Ingleside, Preliminary Plan No. 120140140

Staff Recommendation: Approval with Conditions

Review Basis: Chapter 50

RECOMMENDATION: Approval subject to the following conditions:

Figure 4 – Preliminary Plan

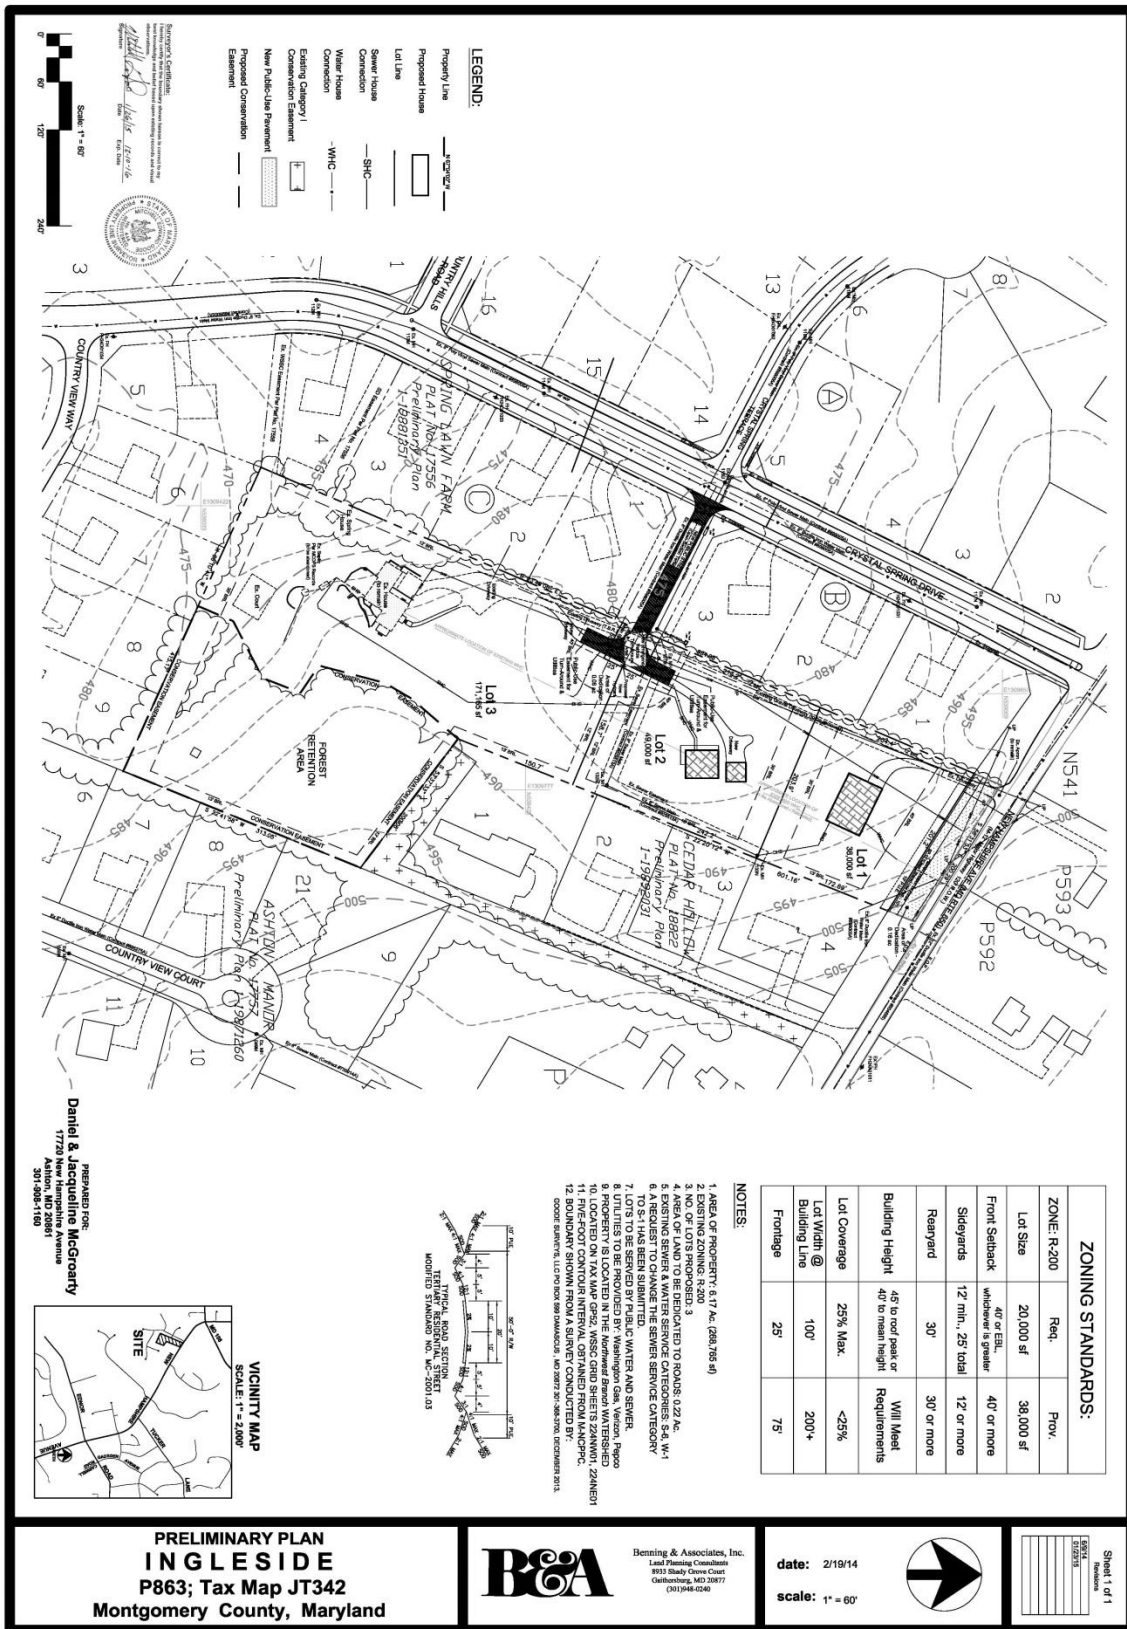
The original submittal of the Preliminary Plan showed access for all 3 lots using a relocated shared driveway coming off of New Hampshire. At the DRC Meeting held on May 5, 2014, Staff, including MCDOT, provided a copy of this covenant to the Applicant and their representatives. Given this legal encumbrance on the Property filed of record 25 years ago, Staff informed the Applicant that their Application must propose access from the existing right-of-way in the adjacent Spring Lawn Farm subdivision. Furthermore, Staff informed the Applicant that failure to meet the terms of the covenant would result in a Staff recommendation of denial.

Over the course of multiple meetings, the Applicant opted to revise their plans and submit a design exception to MCDOT for a new public street located in the existing right-of-way in order to meet the terms of the covenant. The Applicant does not want to construct a full cul-de-sac because of the expense given the minimal amount of lots the Application is requesting and the amount of land it would consume. However, the Property does have remaining density available for possible resubdivision in the future. In theory, the R-200 zoning on the Subject Project would allow 13 lots, however, due to the shape of the Property, required roads and forest conservation requirements, the maximum lot yield would be considerably less. It is possible that the Subject Property could yield five or six lots using a cul-de-sac to terminate and provide lot frontage along Crystal Spring Terrace.

The MDSHA recommends approval of the Application with the existing driveway entrance remaining even though their May 1, 2014 letter (Attachment 5) states that the driveway must be removed if access to all new lots is provided to Crystal Spring Drive. Since the new lot fronting New Hampshire Avenue does not have access to Crystal Spring Terrace, access must be provided to New Hampshire Avenue. Thus, MDSHA is willing to allow Lot 1, as shown on the Preliminary Plan, to maintain the driveway connection to New Hampshire Avenue. The existing house on proposed Lot 3 and the new house on proposed Lot 2 will have access via driveways to Crystal Spring Terrace. Sufficient parking will be provided on the driveways of each house and/or in garages. With the construction of the new terminus for Crystal Spring Terrace, access for the 3 new lots will be adequate.

3. The Applicant must dedicate, by record plat, the following rights-of-way:
 - a. 60 feet from the centerline along their site frontage on New Hampshire Avenue as shown on the Preliminary Plan.

- b. 50 feet for the extension of Crystal Spring Terrace as shown on the Preliminary Plan, unless otherwise determined by the Montgomery County Department of Transportation ("MCDOT") to be unnecessary prior to recordation of the plat.

5. The Applicant must construct the extension of Crystal Spring Terrace as a privately maintained driveway within the existing 50-foot right-of-way from Crystal Spring Drive to the Property boundary and extended as temporary "T-type" turnaround located on the Subject Property. The construction within the Crystal Spring Terrace right-of-way must be to MCDOT Road Code Standard MC-2001.03: Tertiary Residential Street Modified. The modification allows for the reduction of right-of-way from 74-feet to 50-feet, no sidewalks, no street trees and lighting and a reduction in the side ditch area for storm water management.

Figure 5 – Preliminary Forest Conservation Plan

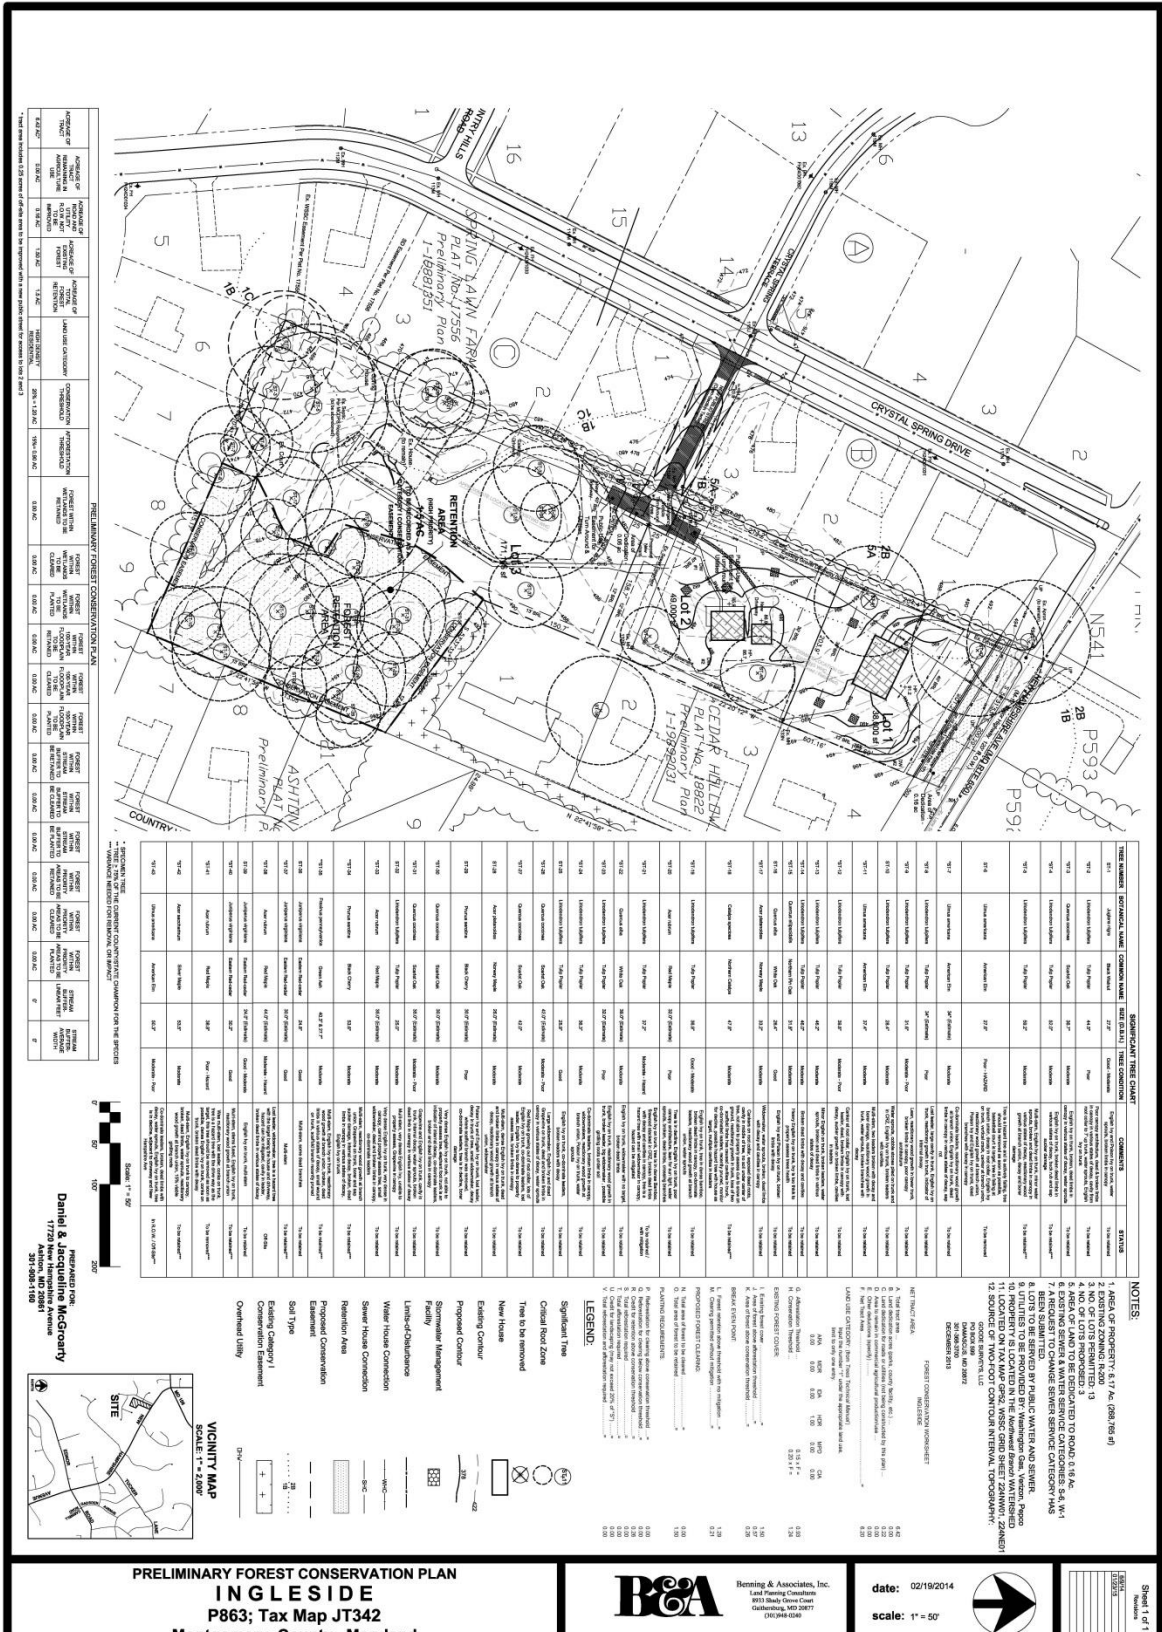
The Application meets the requirements of Chapter 22A of the Montgomery County Forest Conservation Law. A Preliminary Forest Conservation plan has been submitted for review (Figure 5). The existing forest is an isolated upland stand designated as high priority. The proposed development preserves the entire 1.5 acres of existing forest. There are no forest planting/mitigation requirements.

There are 43 specimen trees on and adjacent to this Property. Nine of the specimen trees will be impacted by development and one specimen tree is proposed for removal and discussed in the variance section below.

- a. Prior to Planning Board approval of the record plat, the Applicant must obtain Staff approval of a Final Forest Conservation Plan (FFCP) consistent with the approved Preliminary Forest Conservation Plan and including mitigation for the loss of a specimen tree at a ratio of approximately 1" caliper for every 4" DBH removed, using trees that are a minimum of 3" caliper size.

- b. The Applicant must place a Category I Conservation Easement over approximately 1.5 acres of forest retention as shown on the approved forest conservation plan. The easement must be approved by the M-NCPPC Office of General Counsel and recorded by deed in the Montgomery County Land Records prior to clearing or grading. The liber and folio of the deed must be referenced on the record plat.

Figure 6 – Tree Impacts

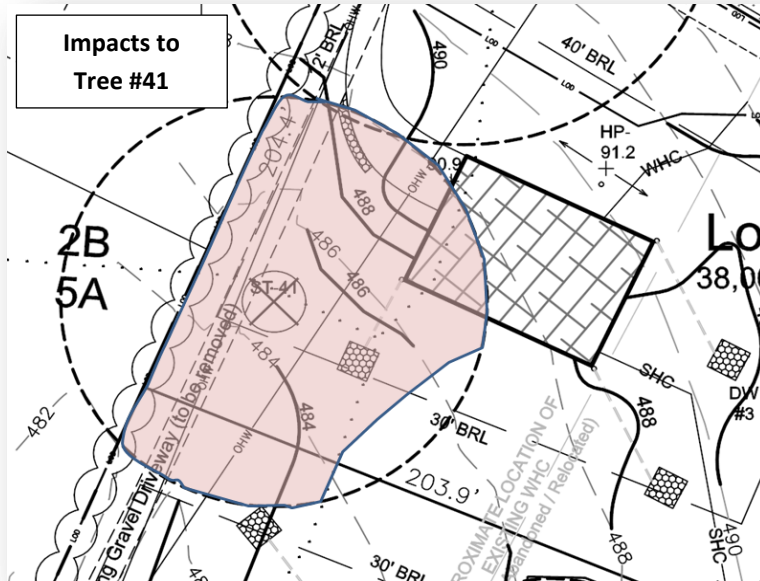
On January 23, 2015, the Applicant requested a Variance for impacts to 9 Specimen Trees and the removal of 1 Specimen Tree (Attachment 8).

There is one (1) tree proposed for removal which is 38.8 inches DBH in this Variance request located outside of the existing forest. Additional mitigation is recommended for this tree at a rate that approximates the form and function of the tree removed. Staff recommends that replacement occur at a ratio of approximately 1" caliper for every 4" DBH removed, using trees that are a minimum of 3" caliper size. While these trees will not be as large as the tree that is removed, they will provide some immediate canopy and ultimately replace the canopy lost by the removal of this tree.

There is some disturbance within the critical root zones of nine Specimen Trees, but they are candidates for safe retention and will receive adequate tree protection measures. No mitigation is recommended for the Specimen Trees that are impacted but retained.

Staff recommends that the Variance be granted with mitigation. The submitted PFCP meets all applicable requirements of the Chapter 22A of the County Code (Forest Conservation Law).

PRELIMINARY PLAN
INGLESIDE
P836; Tax Map JT342
Montgomery County, Maryland

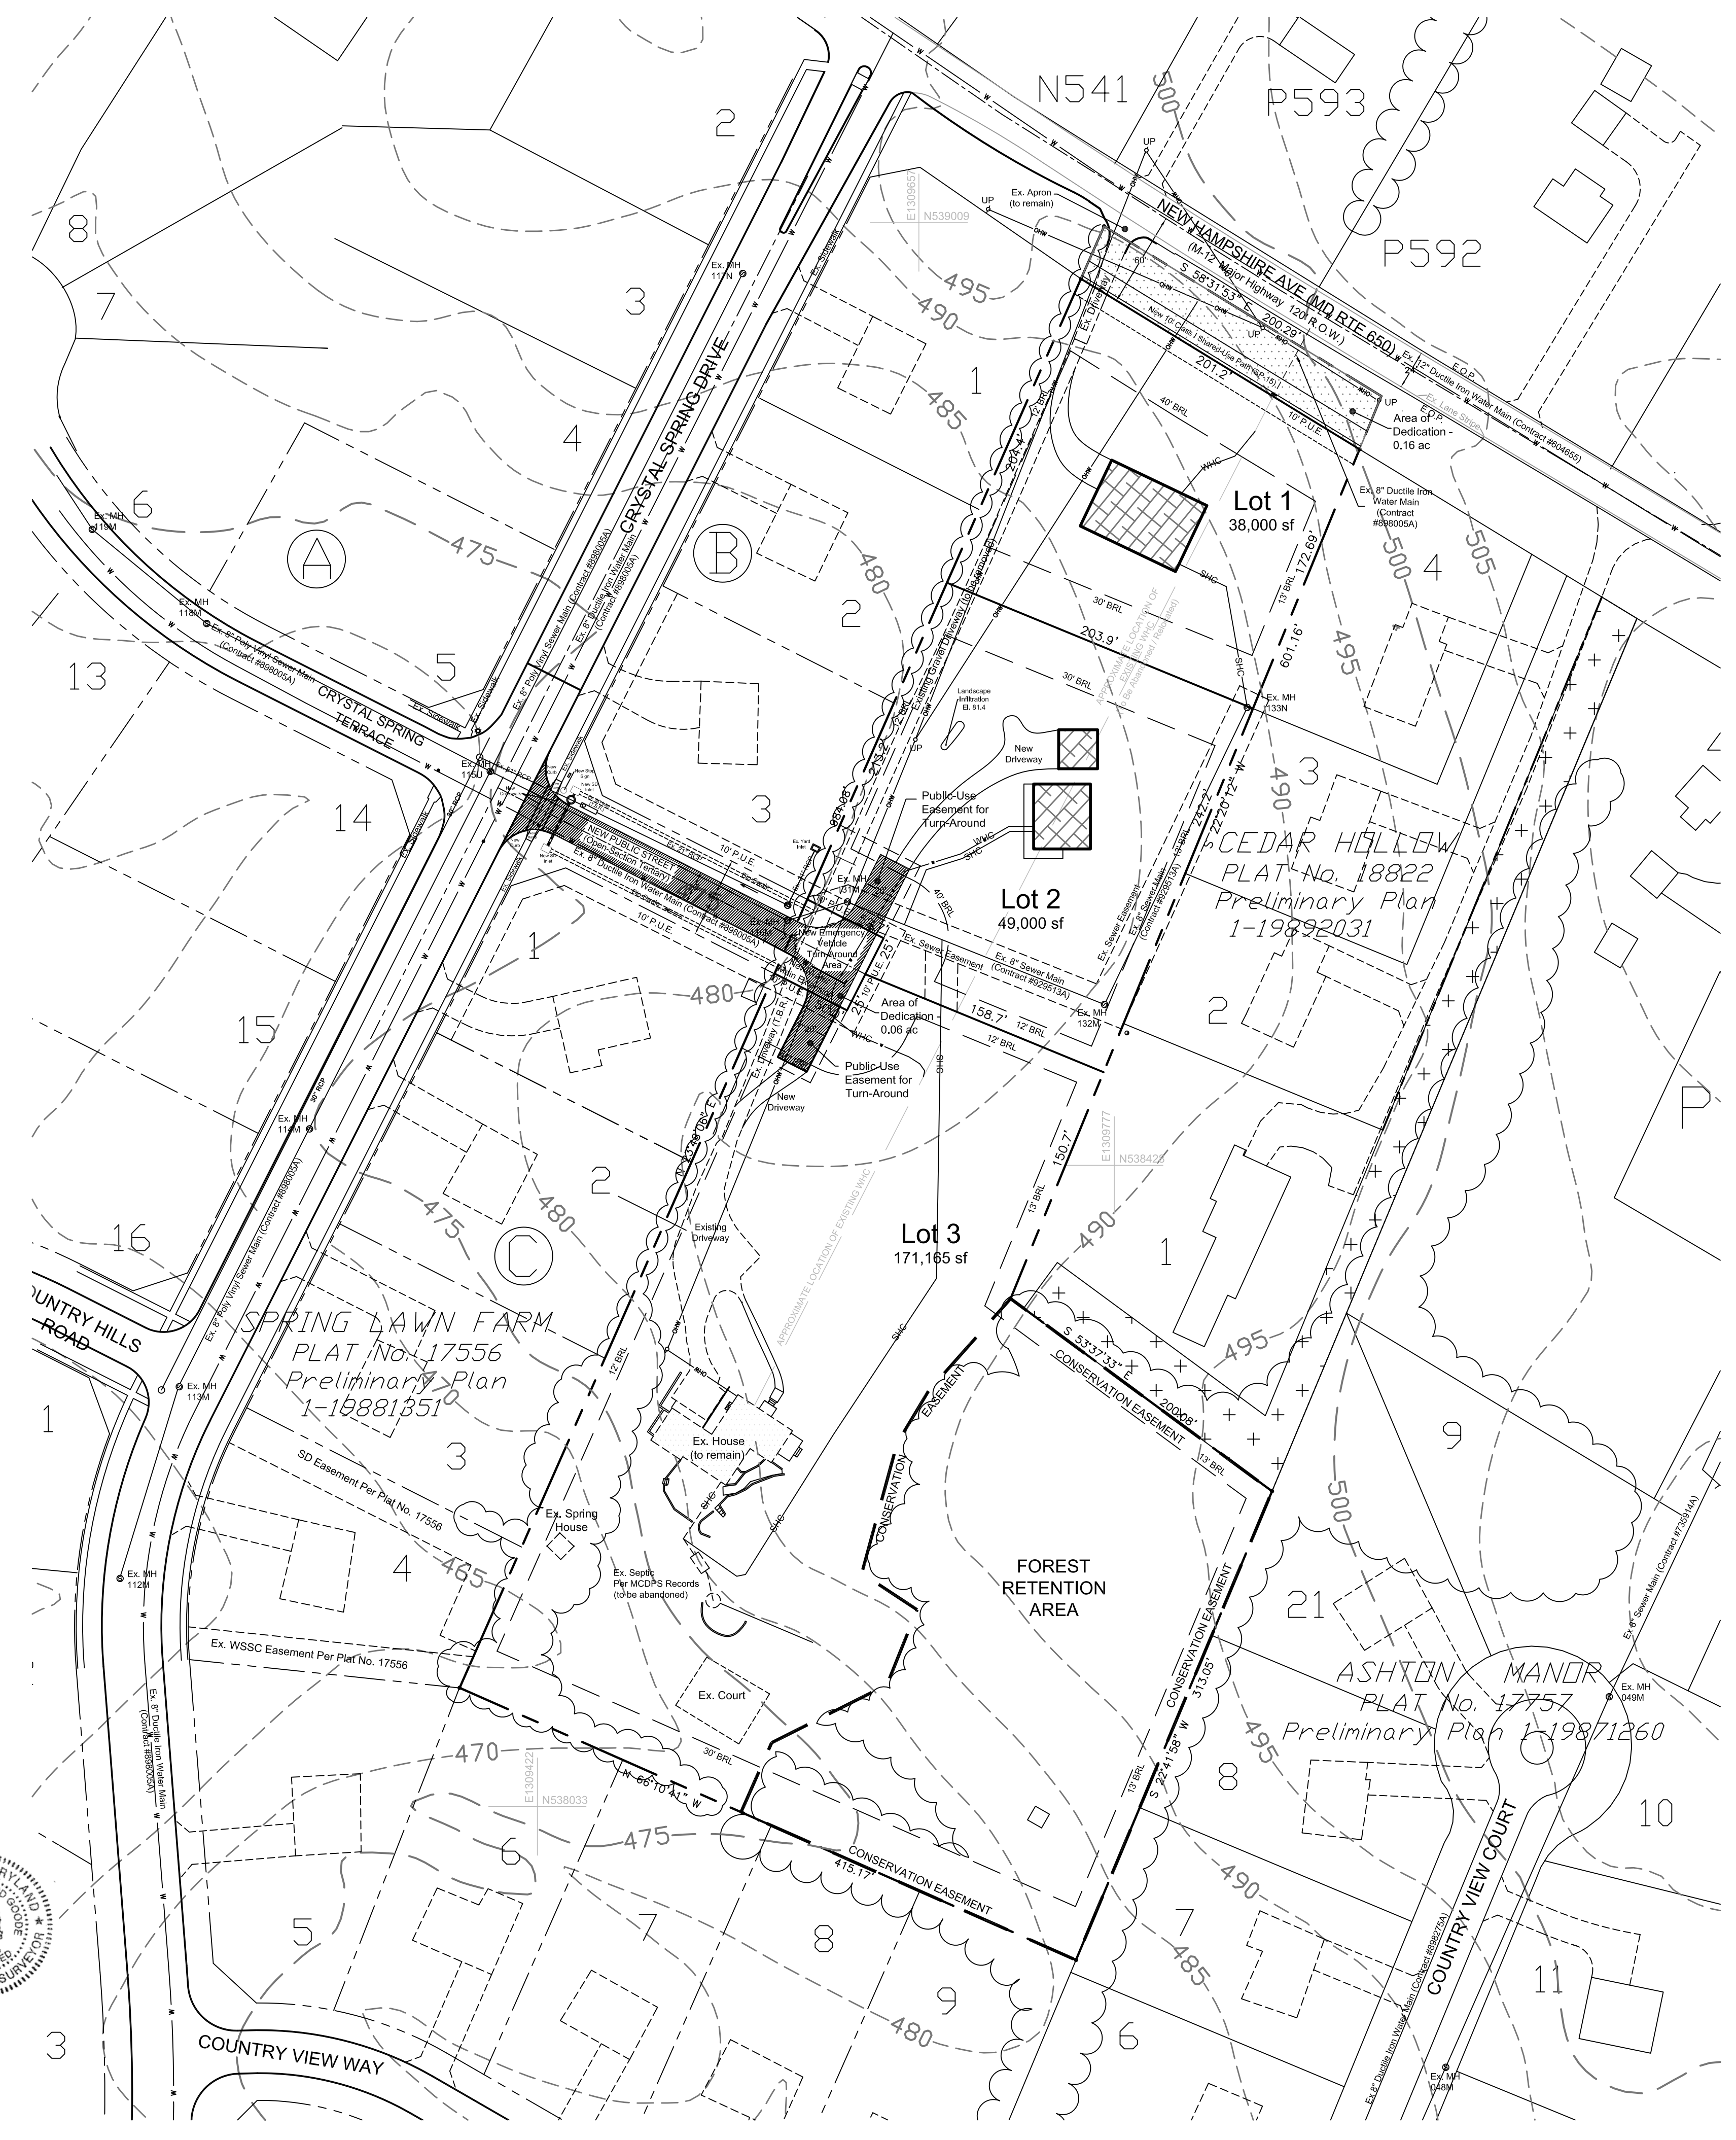
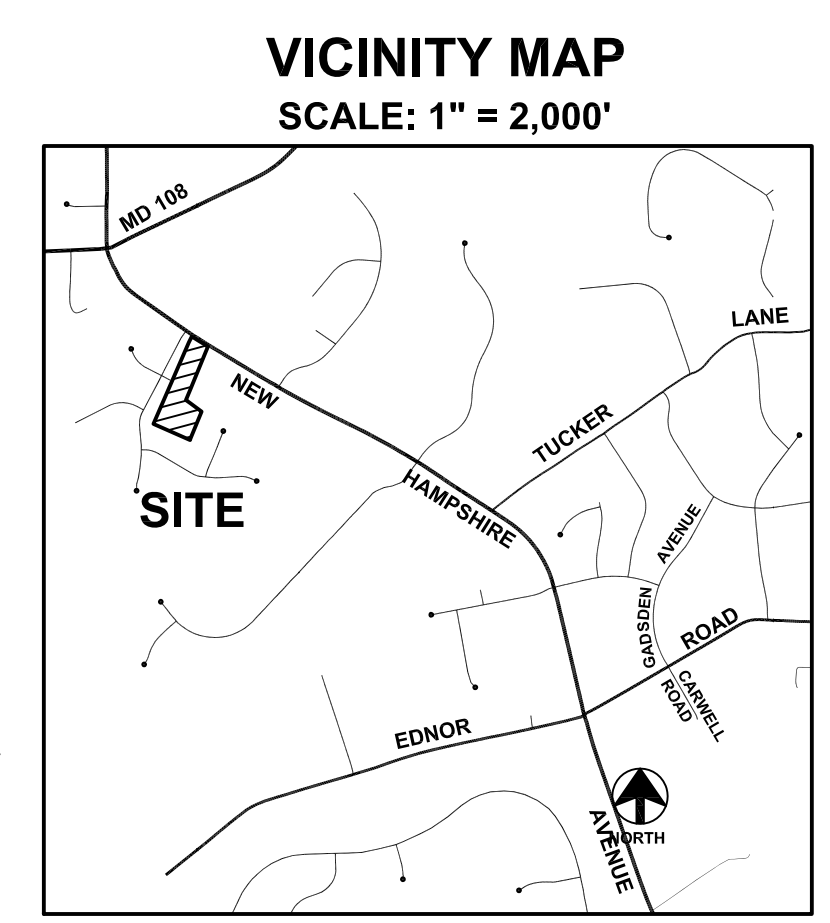
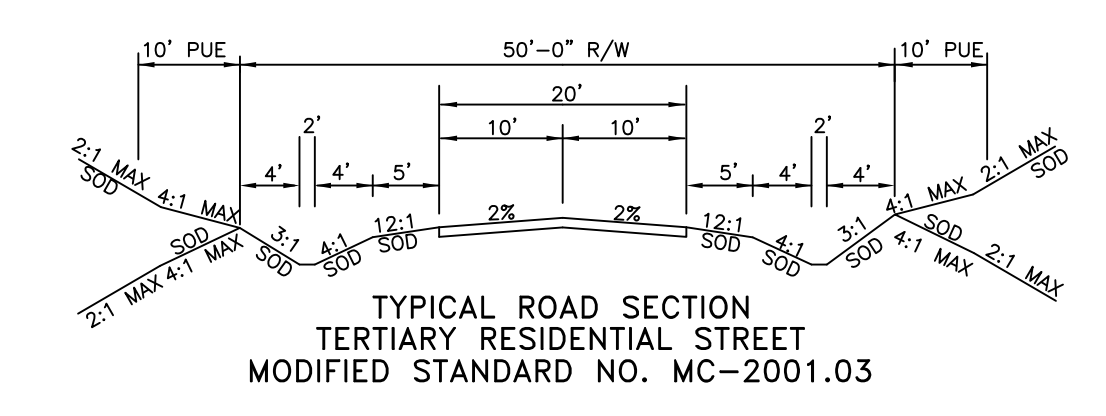
- All previous comments in our August 8, 2014 letter remain applicable unless modified below.
- Comments 1 (first paragraph) [*dedication and construction of Crystal Spring Terrace, terminating in a cul-de-sac*], 6 [*closed section roadway waiver*], 8 (a) and 8 (f) [*permit and bond to construct the extension of Crystal Spring Terrace as a publicly maintained street*] in our August 8, 2014 letter are hereby deleted.

- We accept the applicant's proposal to construct site access per the modified Tertiary Street standard MC-2001.03 terminating in a T- turnaround as shown in the aforementioned revised Preliminary Plan. Modifications to the existing storm drain system within that right-of-way will be necessary to implement the proposed private access. We note that twenty five (25) foot wide slope easements have been granted adjacent to the Crystal Spring Terrace right-of-way under record plat no. 17556; all side slope grading should be confined to those limits.

- The dimensions of the pavement and easement for the proposed T- turnaround should be reflected on the certified preliminary plan.
- We accept the conclusions in the consultant's amended storm drain report – which indicate the existing outfall is adequately sized for the 10 year storm and the spread requirements for the existing inlets on Crystal Spring Drive (a Primary classification street) requirements have satisfied and that the existing pipes have adequate capacity for the post-development runoff. Although the efficiencies for the two inlets on Crystal Spring Drive is indicated to be below the minimum 70% interception required in the Montgomery County Storm Drainage Design Criteria, we will not require the applicant to modify those inlets - as that runoff is primarily off-site and not related to this development. No further drainage analysis is required from DOT.
